**PLANNED UNIT DEVELOPMENT
& SUBDIVISION STAFF REPORT****Date: September 6, 2012****DEVELOPMENT NAME**

Pinebrook Subdivision

Planned Unit Development Approval to amend a
previously approved Planned Unit Development to allow shared access and parking between
multiple building sites, and Subdivision approval to create 5 lots.

SITE PLAN

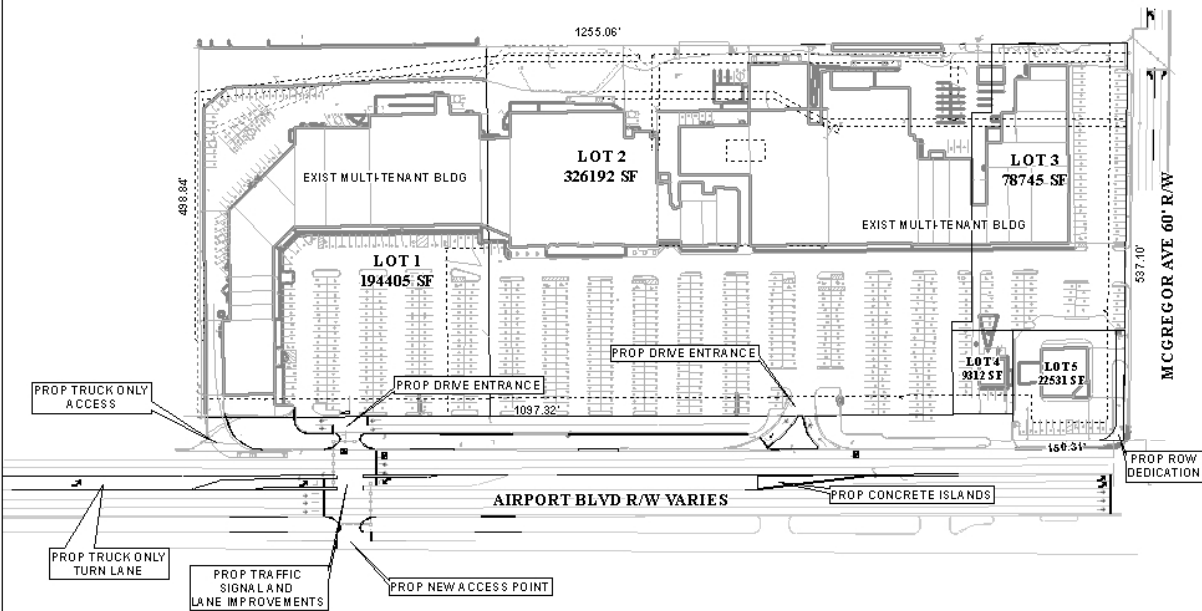
The right-of-way width on McGregor Avenue is not illustrated the same on the Subdivision plan versus the PUD plan. Right-of-way dedication should be consistent across the property frontage, in accordance with the Master Street Plan. A revised traffic impact study was submitted for this development. Traffic Engineering approval of this site is contingent upon the construction by the developer/owner of all improvements identified in the study. It should be noted that the improvements include the installation of a traffic signal near the western property limits on Airport Boulevard and the removal of the traffic signal near the northern property limits on McGregor Avenue. Although it is not clearly stated, the proposed signal must have hard-wire connection via fiber to the existing, adjacent signal system that begins at McGregor Avenue and runs east. This requires compatible signal equipment including but not limited to the controller, detection, and interconnectivity. City standard mast arm installation is also required. The improvements also include physical changes, such as a concrete island, to limit the right-in, right-out driveway on McGregor Avenue; striping will not be considered a physical improvement. Additional driveways on Airport Boulevard must either be modified or closed, as discussed in the study, as well as modifications to the median along Airport Boulevard. Design plans for all improvements within the public right-of-way must be approved by Engineering and Traffic Engineering.

Since dedication along South McGregor Avenue will be required, the subdivision plat and the PUD site plan should be revised to reflect and accommodate the dedication. It should be pointed

The site plan submitted with the PUD application reflects some but not all of the improvements recommended by the TIS, thus the site plan should be revised to specifically show all proposed changes recommended by the TIS or by Traffic Engineering.

The site plan does not accurately reflect the current tenant mix and uses. Tenants are depicted that are no longer present, and other tenants are depicted in locations that are different from their actual location in the development. The site plan should be revised to accurately reflect tenant locations, and to quantify in square feet the uses – retail, restaurant, office, etc. As the site plan tenant mix is not accurate, staff cannot verify adequate parking on the site. Furthermore, as a new tenant is involved, and as no information as the type of parking ratio required for the new tenant is provided, staff cannot determine if parking on site will be adequate. It should also be pointed out that there appear to be several parking spaces located in the service road right-of-way

The site plan also depicts a proposed entry just west of the proposed new traffic signal. Parking spaces depicted behind Write Impression are angled, and the drive width narrows down to about 15 feet: the entry from Airport Boulevard should be signed as “one way” from Airport into the development. Also it appears that parking spaces in the Northwest corner of the site are so arranged to provide inadequate/substandard circulation and maneuvering. The International Fire Code may require a minimum 20-foot wide fire lane around the rear of the building, with the lane 26-feet in width where-ever there is a fire hydrant.

The drive-through for the Marble Slab Creamery is not marked and does not include one-way arrows. The site plan should be revised to include appropriate markings and labels.

Dumpster pads are depicted on the site plan, but aerials and a staff visit to the site verify that there are multiple dumpsters on the site that are not depicted on the submitted site plan, and which would impede implementation of the parking scheme as proposed. The site plan should be revised to show all existing or anticipated dumpsters.

Regarding trees and landscaping, Urban Forestry has requested that the site fully comply with the requirements of the Zoning Ordinance. No information is provided on the site plan regarding total landscape area, frontage landscape area, or trees. The site plan should be revised to reflect compliance with the tree and landscaping requirements of the Zoning Ordinance.

Typically sidewalks are required as part of commercial subdivision applications. A sidewalk waiver was approved for that portion of the Regions Bank site fronting onto South McGregor Avenue, but not along Airport Boulevard. The site plan should be revised to show existing sidewalks, and should either show new sidewalks along the remaining frontages where sidewalks have not been waived, or sidewalk waiver applications should be submitted. Also, a pedestrian crossing should be provided at the proposed signalized intersection, complete with accessible crosswalks.

- 1) Revision of the site plan to depict dedication along the entire frontage of South McGregor Avenue to provide 50-feet from centerline;
- 2) Revision of the site plan to depict any new building footprint that may be proposed to accommodate the prospective tenant for the site;

- 3) Revision of the site plan to reflect compliance with the Traffic Impact Study recommendations and Traffic Engineering comments *(The right-of-way width on McGregor Avenue is not illustrated the same on the Subdivision plan versus the PUD plan. Right-of-way dedication should be consistent across the property frontage, in accordance with the Master Street Plan. A revised traffic impact study was submitted for this development. Traffic Engineering approval of this site is contingent upon the construction by the developer/owner of all improvements identified in the study. It should be noted that the improvements include the installation of a traffic signal near the western property limits on Airport Boulevard and the removal of the traffic signal near the northern property limits on McGregor Avenue. Although it is not clearly stated, the proposed signal must have hard-wire connection via fiber to the existing, adjacent signal system that begins at McGregor Avenue and runs east. This requires compatible signal*

- 5) *Revision of the site plan to accurately depict the tenant location and mix, and to accurately provide tenant space sizes in square feet;*
- 6) *Revision of the site plan to show all existing dumpsters and dumpster pads;*

- 7) *Revision of the site plan to depict a compliant and realistic parking and truck/vehicle circulation scheme, showing any required one-way circulations, even if the scheme will result in a reduction in the total number of parking spaces below what meets typically required parking ratios by use;*

- 9) *Revision of the site plan to label any existing drive-throughs and one-way aisles;*
- 10) *Compliance with Urban Forestry comments (Property to be developed in compliance with state and local laws that pertain to tree preservation and protection on both city and private properties (State Act 61-929 and City Code Chapters 57 and 64). Full compliance with landscaping and tree requirements of the Zoning Ordinance.);*

- 11) *Revision of the site plan to depict existing sidewalks, and new sidewalks along all other road frontages where they have not been waived by the Planning Commission;*

- 12) *Revision of the site plan to depict an accessible pedestrian crossing at the proposed signalized intersection; and*
- 13) *Revision of the site plan to provide tree and landscape area information to depict full compliance with the tree and landscaping requirements of the Zoning Ordinance.*
